# DCC Dual Power Breaker – Design Fault Fixed

## Introduction

During the recent spell of very hot weather in some places, a design fault revealed itself in the Dual Power Breaker (DPB), as published in the [June](#) and [July](#) 2025 issues of MRH Magazine. When an overload was detected in either DPB district, both districts shut down and then either proceeded to rapidly reconnect and disconnect continuously, or refused to reset at all.

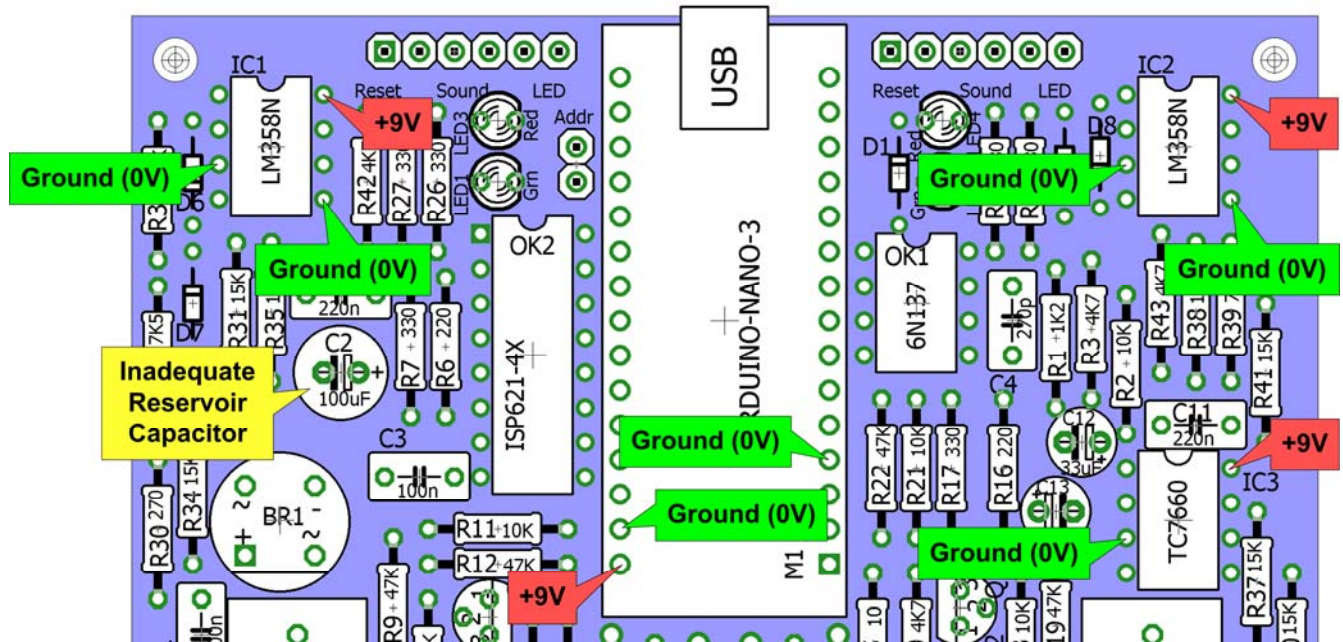
The DPB's 9V voltage regulator (VR1) is powered from the track DCC supply via bridge rectifier BR1 (see my A-Train Systems website at <https://www.a-train-systems.co.uk/dpb-download> for technical details). When a track short circuit occurs, the DCC supply drops to zero, leaving the DPB circuitry dependent for its operation on the residual charge stored in the voltage regulator reservoir capacitor C2. When there is a high ambient temperature not only does the voltage regulator output tend to drop, but this charge leaks away faster, leaving the DPB circuitry without adequate power and so triggering the faulty operation observed.

My design error was setting the value of capacitor C2 at only 100uF. This is insufficient to hold up the DPB onboard supply for the default overload delay time of 25msec at higher temperatures – and the DPB fails. During testing, I now realise that I had a connection to the Arduino USB port for almost all of the time, so that I could monitor the behaviour of the DPB – but without appreciating that this was completely masking the design flaw.

## 1. Additional capacitor connection points

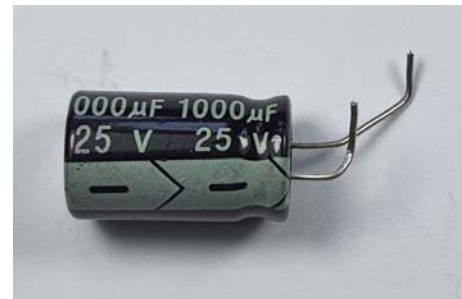
To meet most operational needs, my recommendation is to fit a 1000uf 25V capacitor to the DPB, leaving the existing 100uF capacitor (C2) in place. Note that I have chosen a voltage rating of 25V to reduce the physical size (rather than my normal selection of 35V). For long term reliability do not use a capacitor with a lower voltage rating. The extra capacitor is connected between the +9V output from voltage regulator and ground (0V), and suitable connection points on the PCB are labelled in diagram [1].

The easiest place to fit the capacitor, given its relatively large size (10mm diameter x 17mm), is beside C2, between BR1 and IC1, with the positive lead going to IC1 pin 8 (+9V) and the negative lead (indicated by a stripe on the side of the capacitor) going to IC1 pin 3 (Ground).

## 2. Preparing the capacitor leads

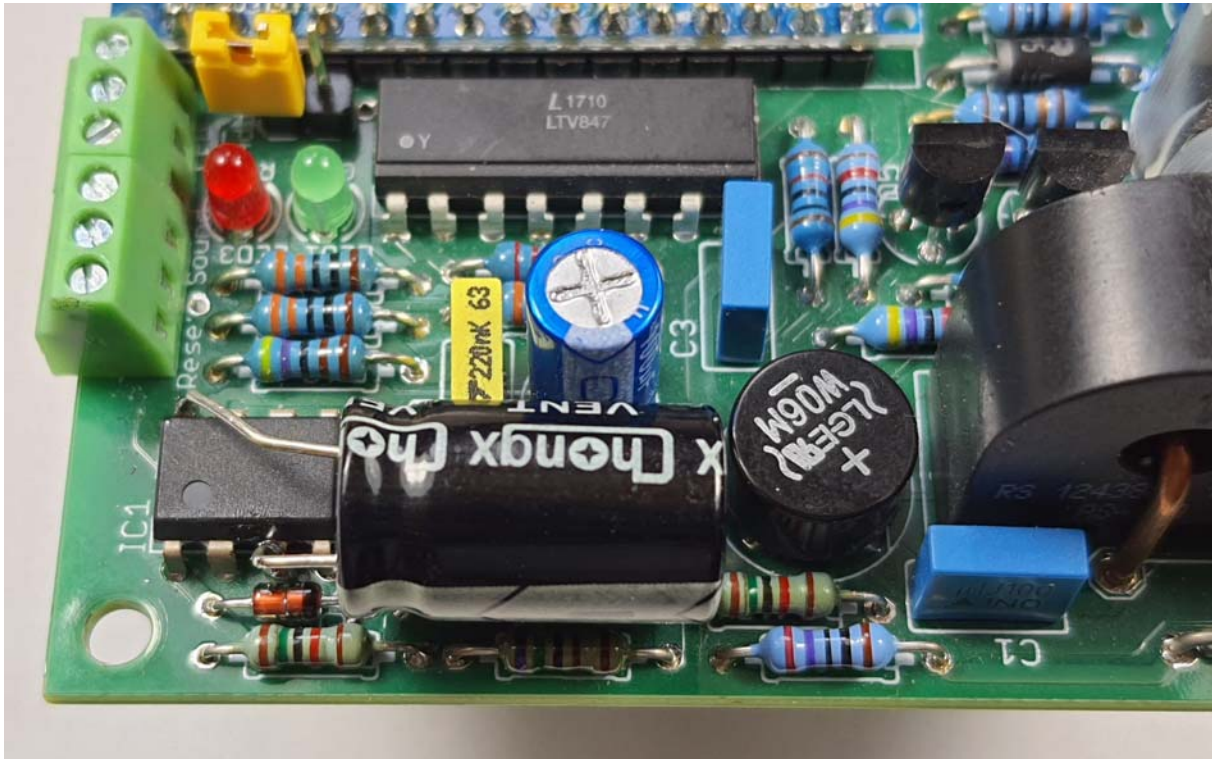
Bend and trim the capacitor leads as shown in [2] below so that they match the positions of IC1 pins 3 and 8 when the capacitor is held in place.

With a fine-tipped soldering iron, and thin, resin-cored solder wire, carefully tin pins 3 and 8 of IC1 and the ends of the capacitor leads ie. coat them with a small amount of solder. Get a small amount of solder on the tip of the iron, offer the capacitor leads up to the IC1 pins one at a time, then touch the iron to both pin and lead together to complete a sound solder joint. This method avoids having to attempt to manoeuvre component, solder wire and iron into the correct position simultaneously.

3. Capacitor fitted – side view

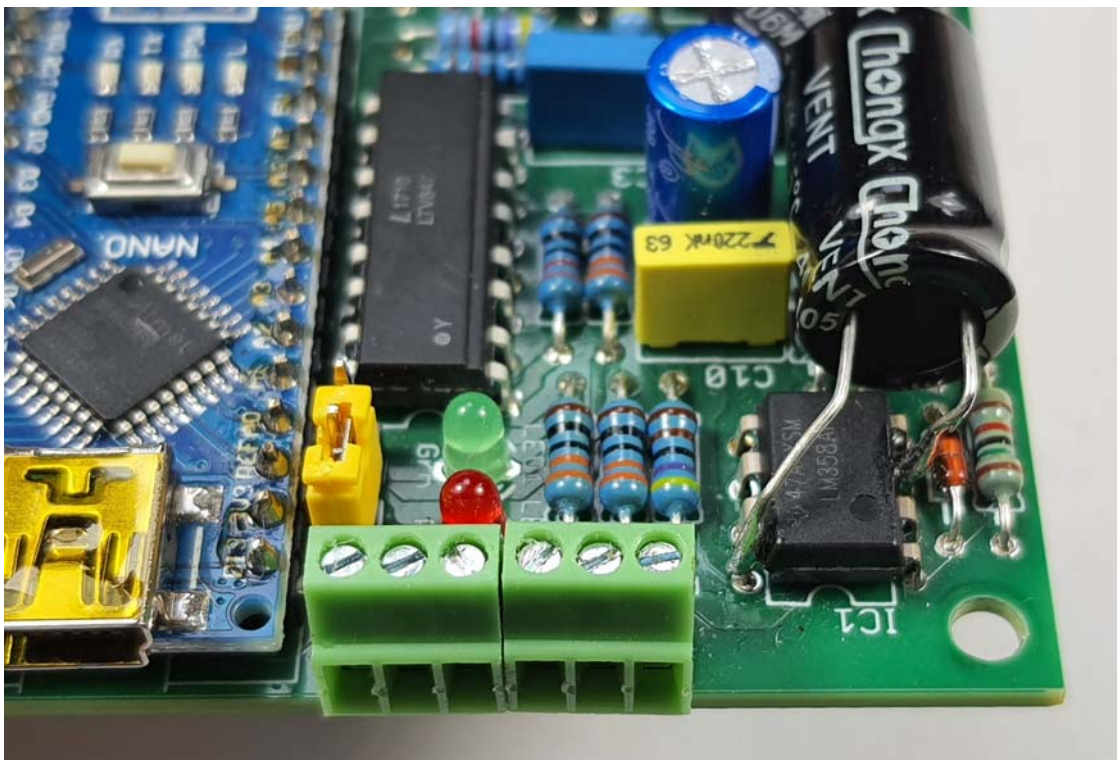
The result should be as shown in [3] and [4] –

With the larger capacitor fitted, the DPB will now operate correctly with overload delay periods of up to 90msec, which should be adequate for the majority of layout situations, but bear in mind that the nominal value of electrolytic capacitors is generally subject to a  $\pm 20\%$  tolerance.

## 5. DPB setup commands – Arduino IDE Serial Monitor

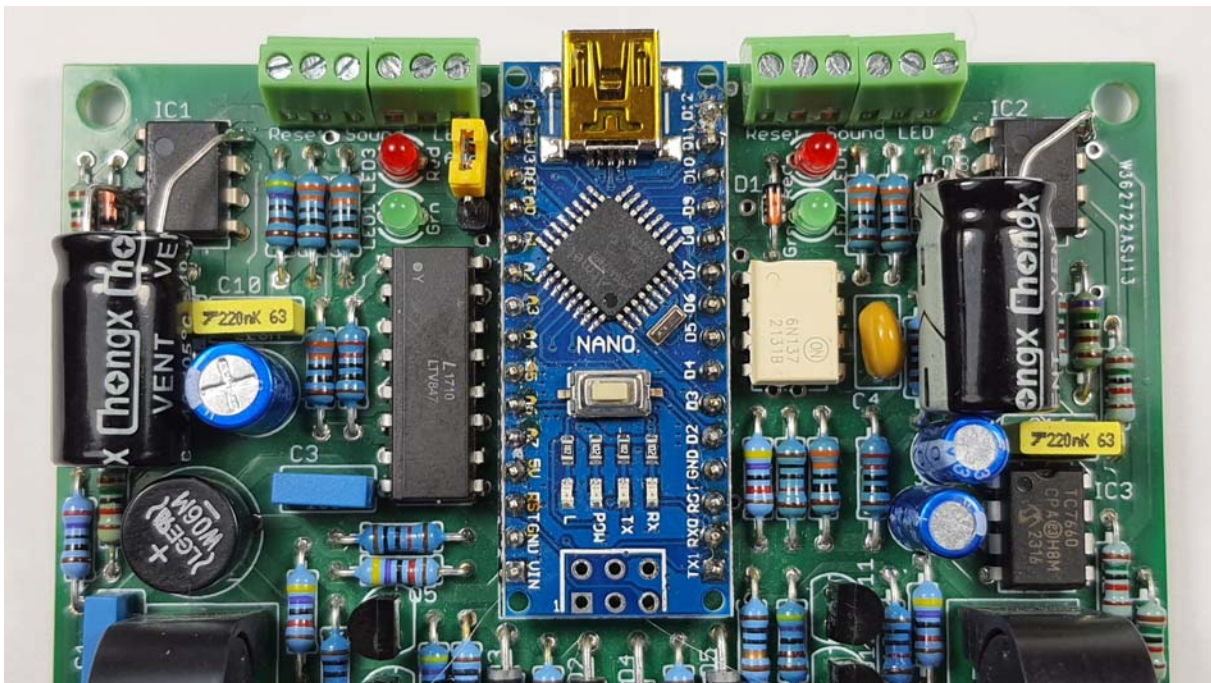
The Version 3.9 code now includes an additional instruction 'H' which you can use, via the Arduino IDE Serial Monitor, to display a list of all available DPB setup commands with their allowed parameters, as shown in [5] –

6. Two capacitors fitted

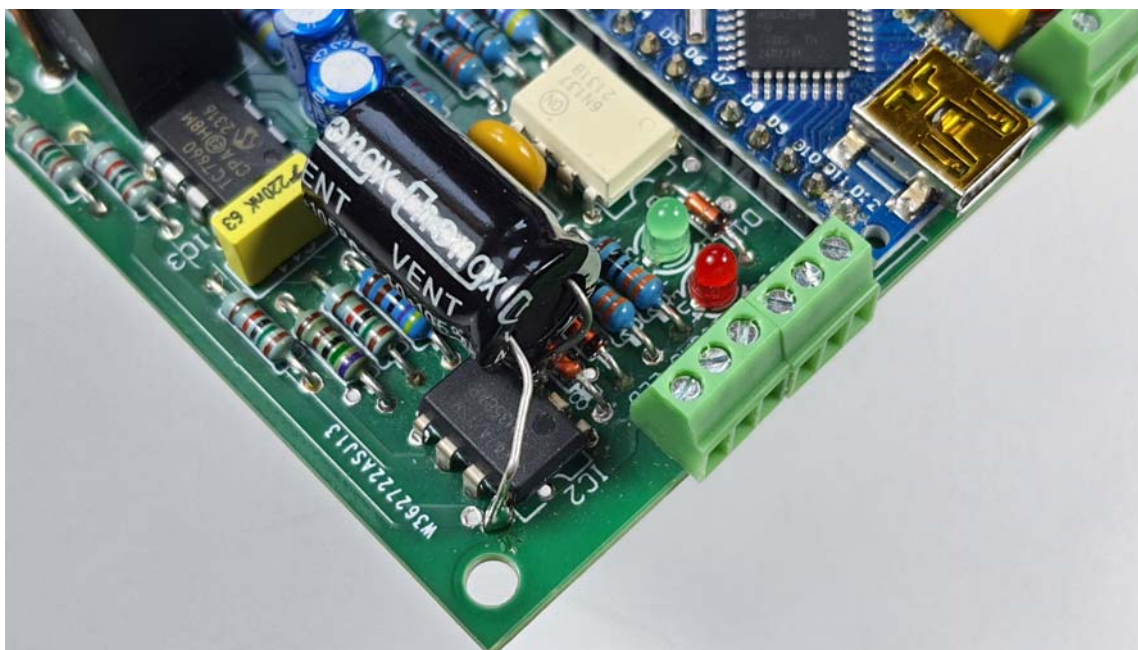
The maximum trip delay which you can set has been left at 255msec although, with the additional capacitor fitted but without a direct USB connection, reliable operation is only available up to 90msec delay. If you really need to set a trip delay beyond 90msec or so then you have the option of fitting a second 1000uF 25V capacitor to pins 3 and 8 of IC2, as shown in [6] –

Space for the second capacitor between existing components is a little more limited, so you need to bend the wires closer to the capacitor body to get it to fit in tidily, as shown in [7] –

With the second capacitor fitted, you can safely set trip delays of up to around 175msec for either or both districts should your layout power connections demand it.
